## PLANNING COMMISSION REGULAR HYBRID MEETING

Subject: Gere Automotive Follow-Up

# COMMUNITY DEVELOPMENT DEPARTMENT STAFF REPORT TO THE DESIGN REVIEW BOARD

FILE NO.: DRB22-0009 DATE: October 17, 2022

Attachment 1: Gear Automotive Design Review Colors

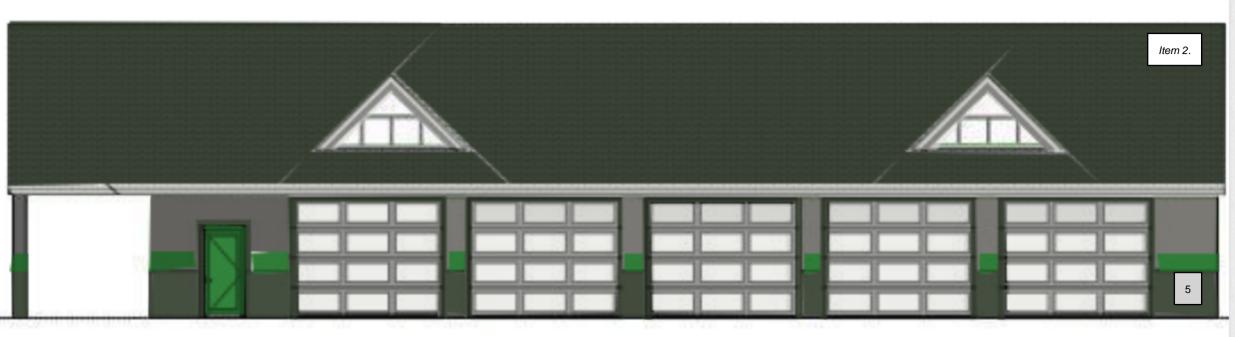
On October 17, 2022, the Planning Commission, acting as the Design Review Board, approved a change of use of an existing building at 9025 Meadowbrook Way SE from a bank/credit union to a vehicle service and repair shop, subject to four conditions (DRB22-0009). The final condition, which the Planning Commission added, required that the applicant "submit a subdued (Northwest) color scheme at a meeting of the Design Review Board for approval prior to painting the building." The applicant has submitted their proposed color scheme, which will be presented to the Planning Commission at this meeting.

- 1. The applicant shall obtain a building permit prior to construction.
- 2. The applicant shall submit proposed lighting designs to the Community Development Director for approval prior to construction.
- 3. Signage requires separate permit.
- 4. The applicant shall submit a subdued (Northwest) color scheme at a meeting of the Design Review Board for approval prior to painting the building.
